INSTRUCTIONAL BULLETIN NO. 2001-12

SUBJECT: NPDES Line

SUPERCEDES: Plan Preparation Guide, Table on Page 12-4 **RE**: Engineering Directive Memorandum PC 28 (2nd Revision)

NPDES Area

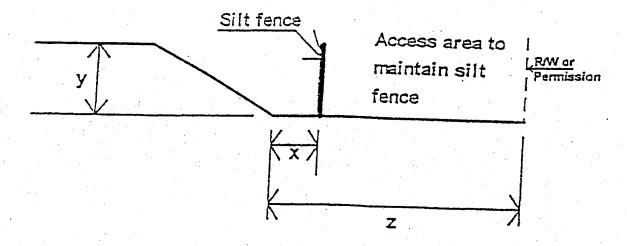
Please be aware of the change from zero (0) feet to three (3) feet where the fill section is less than five (5) feet. This change is to be effective immediately. As a point of clarity, NPDES lines are to be shown whenever there is a fill slope of any height. The purpose of the NPDES line is to show the Contractor where it is necessary to clear and grub outside of the Construction Limits line, especially when the Clearing and Grubbing pay item is within Roadway. When the Clearing and Grubbing is within Right of Way, then the NPDES line is only necessary when it extends outside of the Right of Way line.

Height Of Fill (y)	Minimum Silt Fence Offset from Toe of Slope (x)	Minimum Right of Way For NPDES Lines (z)
<(5)	0	(3)
(5-10)	(3)	(18)
>(10)	(5)	(20)
